RFP#16-18
FOUNDRY PLACE PARKING
GARAGE PERCENT FOR ART PROJECT
PORTSMOUTH, NH
November 28, 2017

Addendum#1

This Addendum forms part of the original document marked: RFP#16-18 Foundry Place Parking Garage Percent for Art Project.

A-410

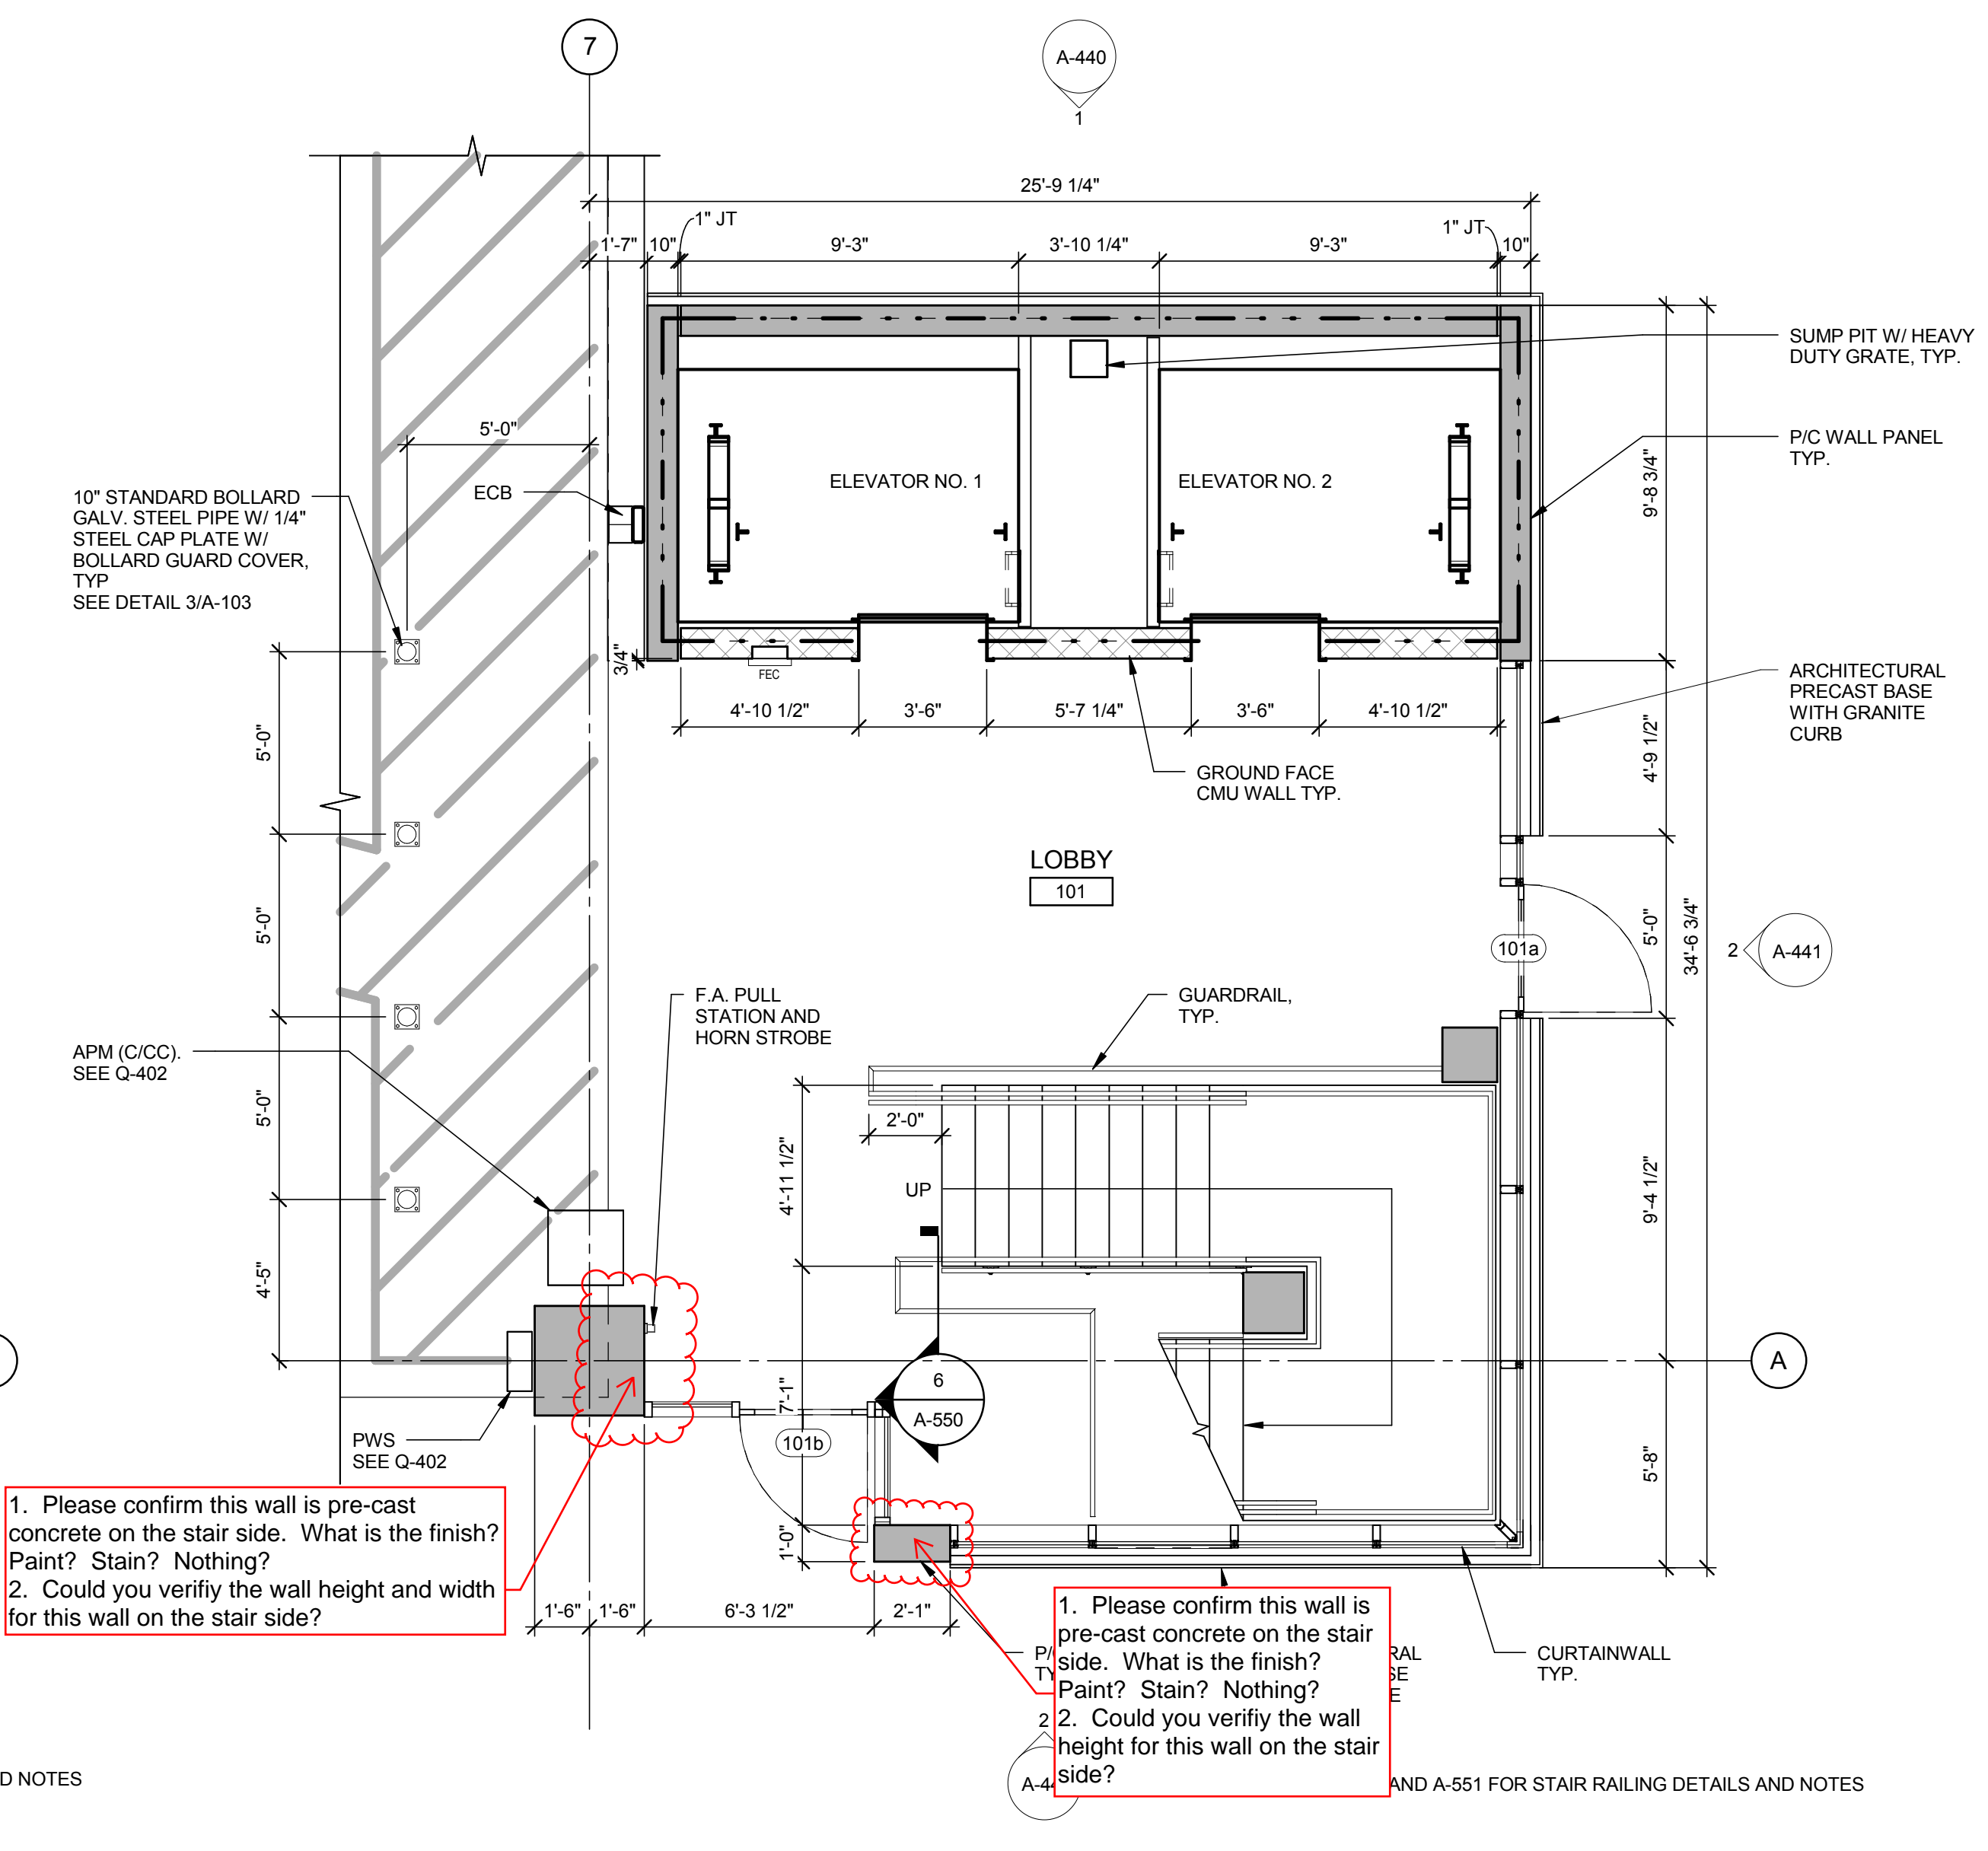
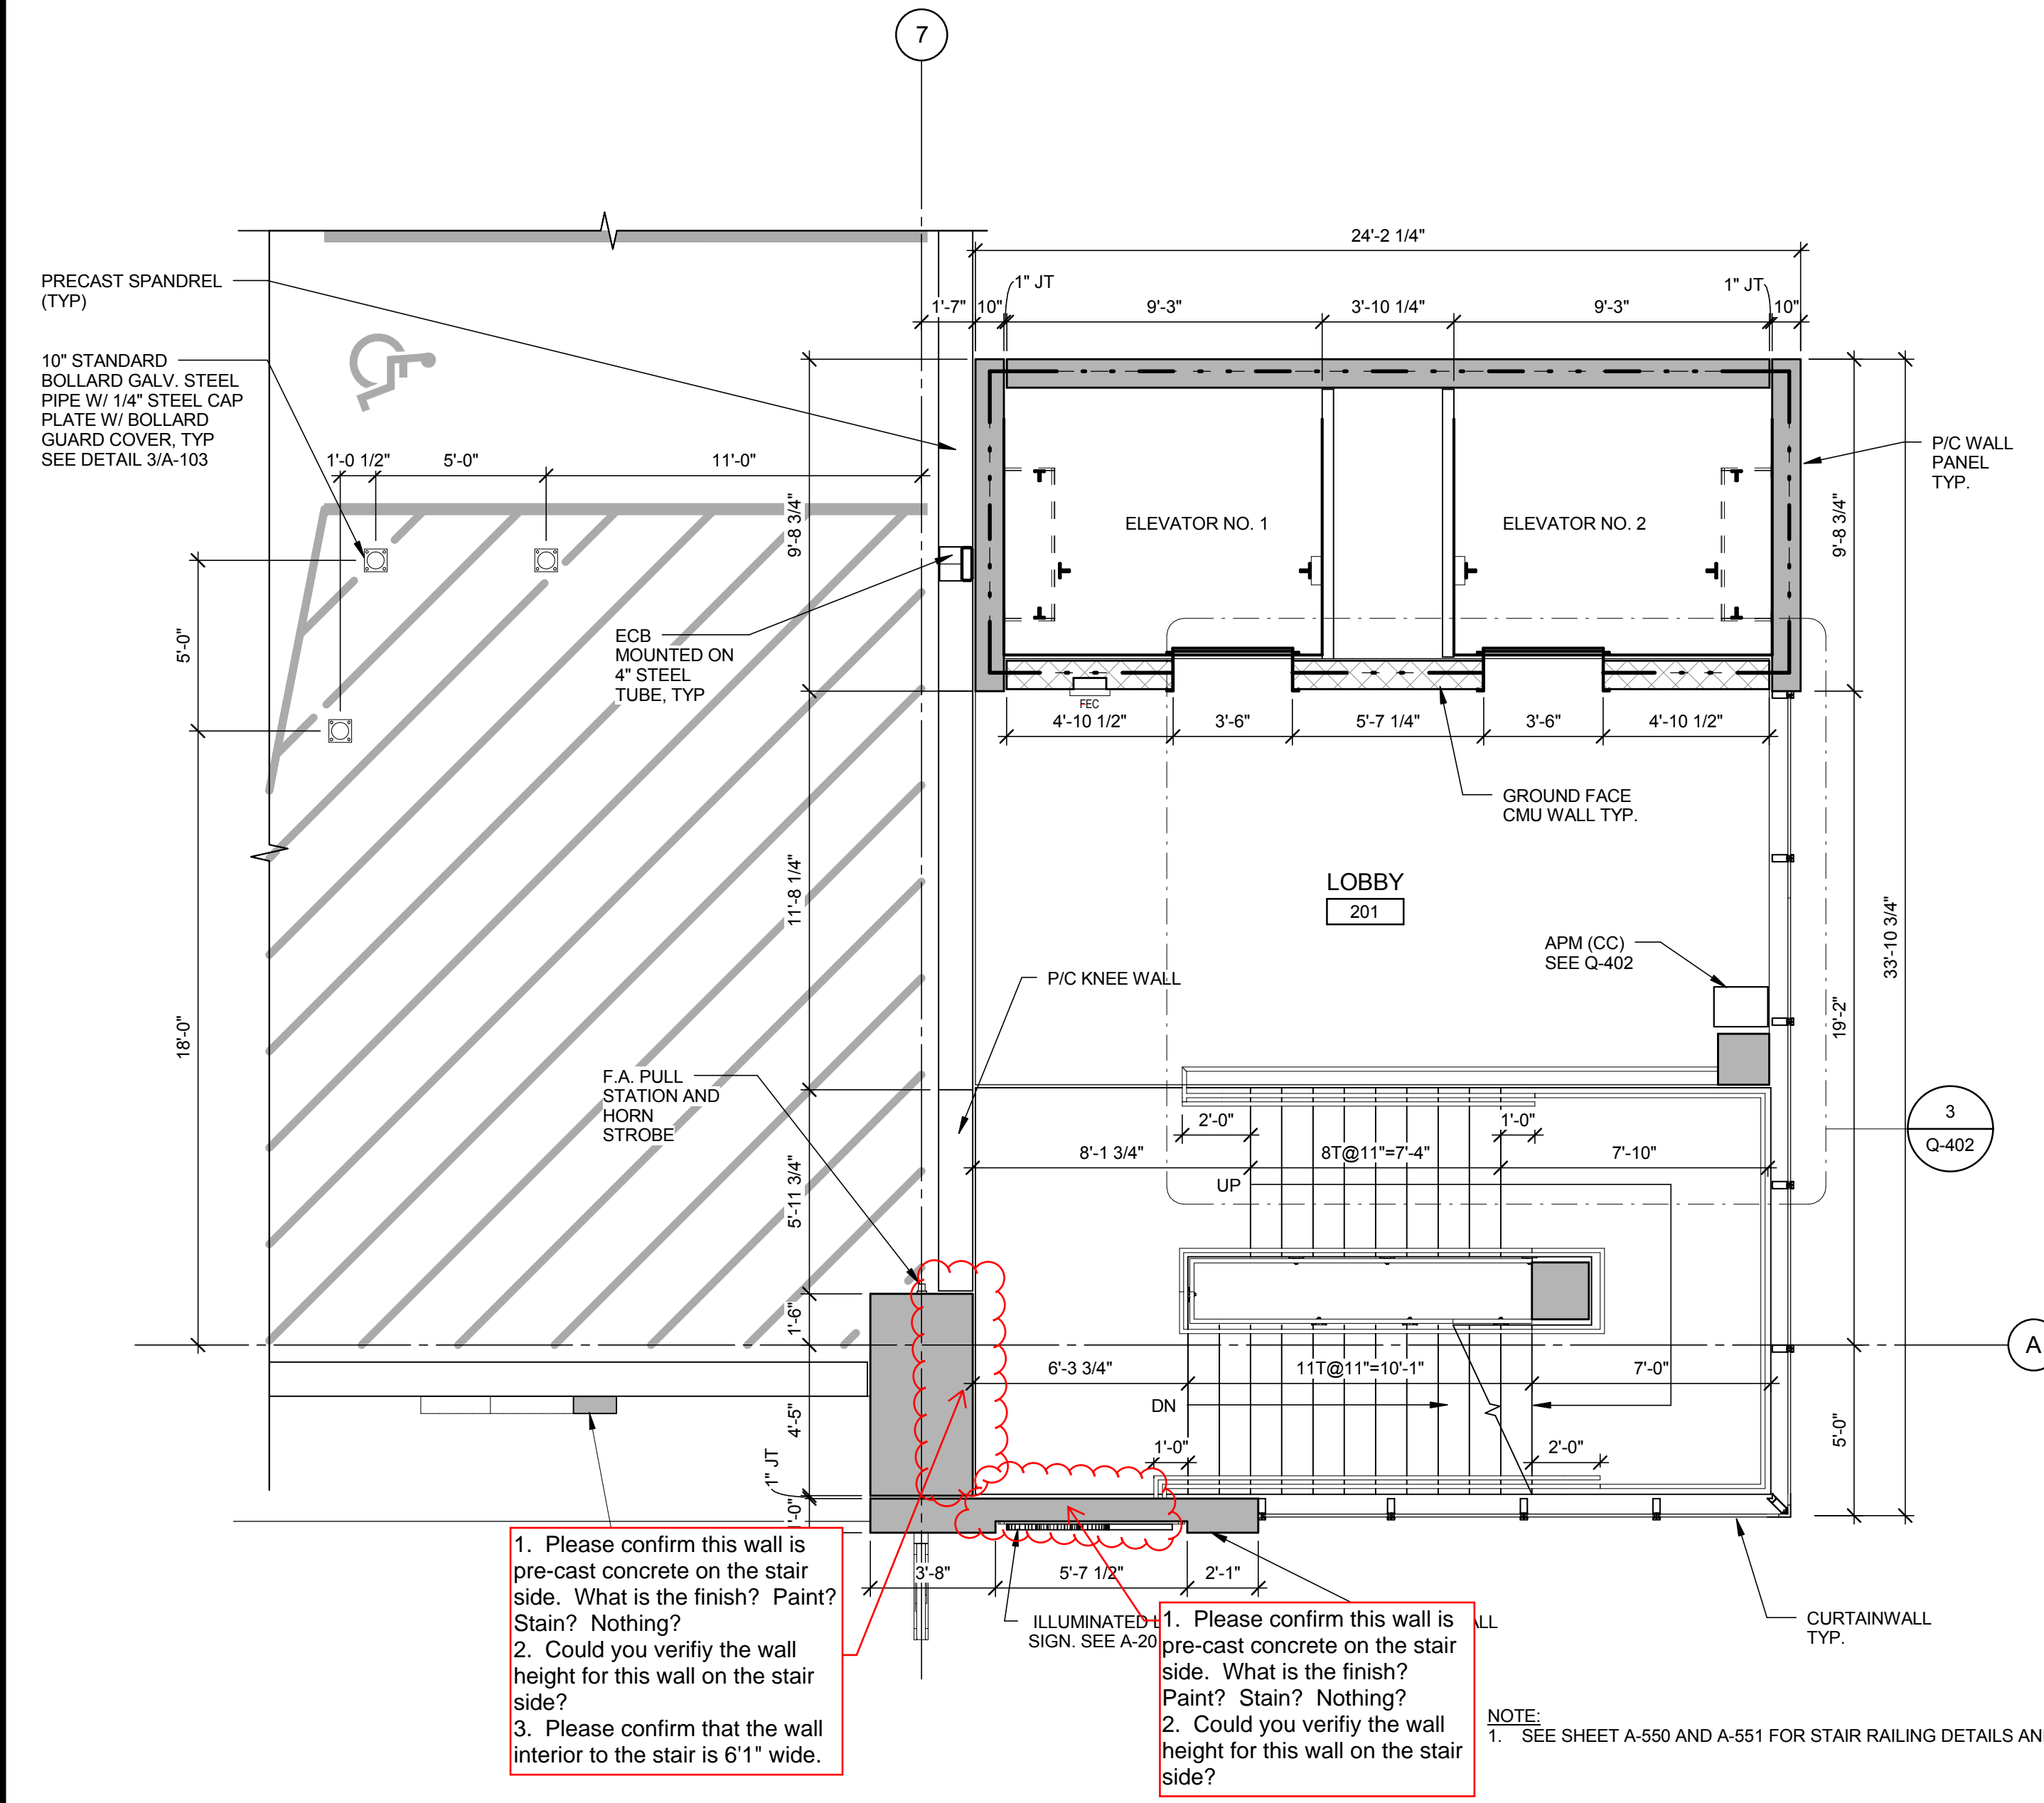
Q: Could you perhaps highlight on the floor plan(s) where the long blank interior wall that could be used for art is located?

Q: If there are additional walls that would contain a decent amount of blank space, could those be highlighted (drawings A101 through A106)?

Q: What is the finish of the wall, and what are the dimensions - both width and height?

Q: On any of these walls, including the ones highlighted on the attached plans, could you call out where any interior signage such as floor numbers, exit signs, etc. would be?

A: See attached annotated plan(s).

A: See attached annotated plan(s).

A: See attached annotated plan(s).

A: See attached annotated plan(s).
